Multipoint high-fidelity CFD-based aerodynamic shape  
optimization of a 10 MW wind turbine *Wind Energy Science*  
Manuscript ID: <https://doi.org/10.5194/wes-2018-66>

## Reviewer 1 Comments and Response

Figure 1: Example of deep convergence

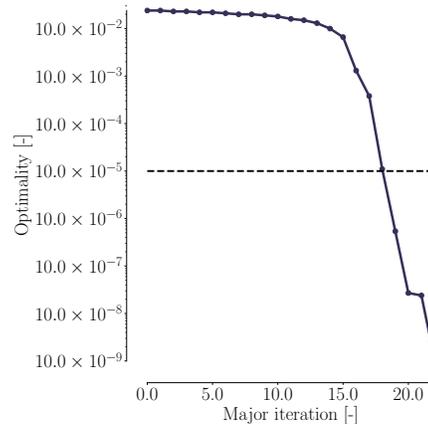
**Comment 12:** Content comment: "Page 8 Line 11: The statement that your cases converge typically well below  $1.0e-4$  is not true. Figures 19 and 22 show other behavior. Please differentiate more on that."

**Response:** We changed the lines concerning the convergence of the design optimization problem. See last line of penultimate paragraph on p. 9. Table 2 was also changed. We did not give illustrations of cases with deeper convergence as seen in Fig. 1, as it was found superfluous.
